Access Compliance Report

Public Rights-of-Way

Intersection ID: 14299	Main Street: N_I-77_EXIT_8_RA	Cross Street: REMOUNT_RD	Location: W
ADA ID: 7C305FC590C5	Ramp Type: PerpDiag	Initial Pass/Fail: Fail	Overall Compliance: No
Severity Score: 13.75			
Codes/Mitigation Info/Possible Solution		Field Measurements/Component Compliance

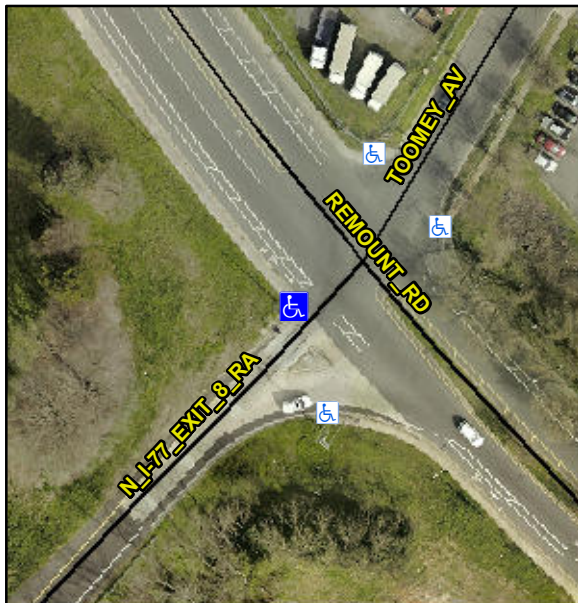
Not Found, R304.2.2, R304.5.3

Compliance	Description	Data	Compliance	Description	Data
N/A	Ramp Length (in)	67.0	No	Ramp Slope (%)	9.9
Yes	Ramp Width (in)	48.0	No	Ramp XSlope (%)	2.1
N/A	Flare Type LT	N/A	N/A	Flare Type RT	N/A
N/A	Flare Slope LT (%)	N/A	N/A	Flare Slope RT (%)	N/A
N/A	Flare Traversable LT?	N/A	N/A	Flare Traversable RT?	N/A
N/A	Landing Length (in)	N/A	N/A	DWS Provided?	N/A
N/A	Landing Width (in)	N/A	N/A	DWS Contrast?	N/A
N/A	Landing Slope (%)	N/A	N/A	DWS Length (in)	N/A
N/A	Landing X Slope (%)	N/A	N/A	DWS Full Width?	N/A
N/A	Landing Curb? (Y/N)	N/A	N/A	DWS Offset (in)	N/A
N/A	Shared Landing?	N/A			
N/A	Gutter Ponding?	N/A	N/A	Gutter Slope (%)	N/A
N/A	Gutter Lip Ht (in)	N/A	N/A	Gutter X Slope (%)	N/A
N/A	Painted X Walk1?	No	N/A	Painted X Walk2?	No
	X Walk 1 Direction	To S		X Walk 2 Direction	To NE
N/A	X Walk 1 Width (in)	N/A	N/A	X Walk 2 Width (in)	N/A
	X Walk 1 Slope (%)	2.5		X Walk 2 Slope (%)	4.6
	X Walk 1 X Slope (%)	1.6		X Walk 2 X Slope (%)	1.7

Remove & Replace Curb Ramp With Two New Directional Ramps or Equivalent.
